REMARKS

I. Interviews

II. Drawings

FIG. 2A

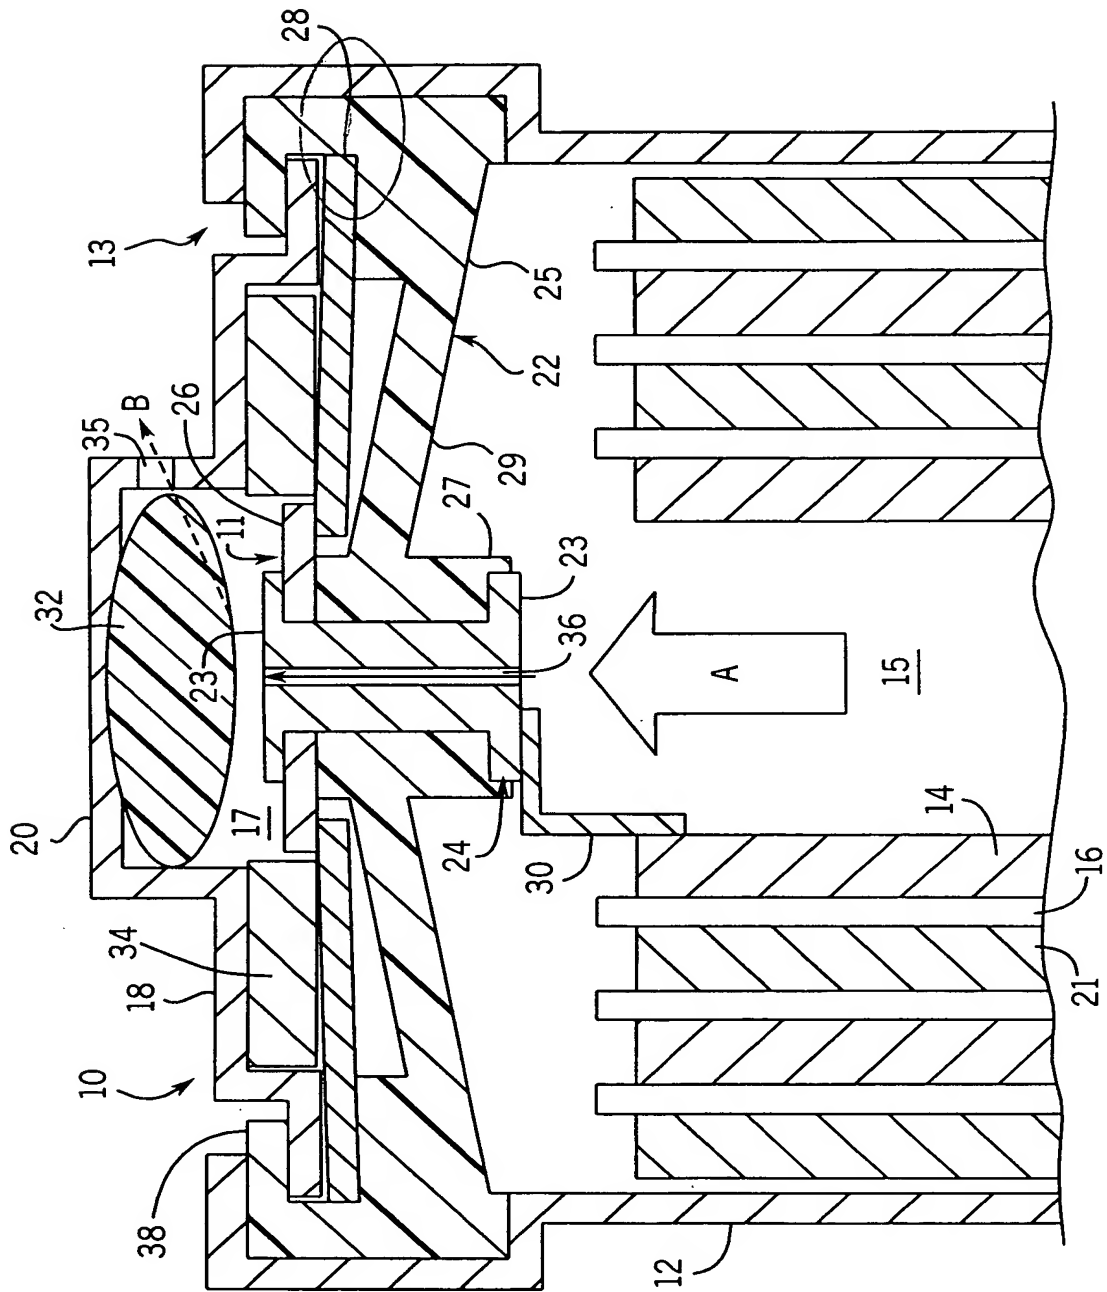
The drawings were objected to because the lead line from reference sign "28" in Fig. 2A leads to a different structure than that in Fig. 2B. Fig. 2A has been revised to properly identify the annular contact by reference numeral "28" in a manner consistent with Fig. 2B.

An annotated marked-up Fig. 2A is enclosed with the change identified in red ink. A Formal Sheet 2 bearing Fig. 2A incorporating the above drawing change is also enclosed for approval by the Examiner.

An annotated marked-up Fig. 2A is enclosed showing changes to reference numeral "28" in red ink.
